AERONAUTICAL CHARTING MEETING
Charting Group
Meeting 22-02 – October 25-27, 2022

RECOMMENDATION DOCUMENT

FAA Control #22-02-375

Subject: FAA Charting depictions of stopways and blast pads

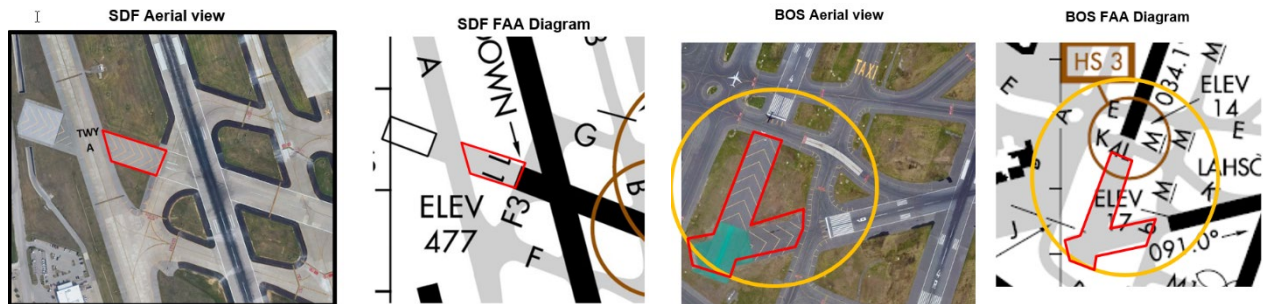
I reached out to Jeppesen to alert them about this discrepancy. Jeppesen has since agreed to correct the stopway depiction on their SDF Diagram. The stopway will now appear in accordance with their charting legend indicated in this figure:

However, the FAA Charting standards depict all stopways, taxiways, and ramps using the same shading. This is potentially confusing for flight crews at airports where stopways are traversed by taxiways. (e.g. SDF, PHL, BOS). See SDF and BOS, below:

Change the depiction of stopways on FAA airport diagrams to appear differently than taxiways. Changing the chart image would prevent potential flight crew confusion in situations where visibility is limited, or painted chevrons are obscured by contaminants such as snow or ice.
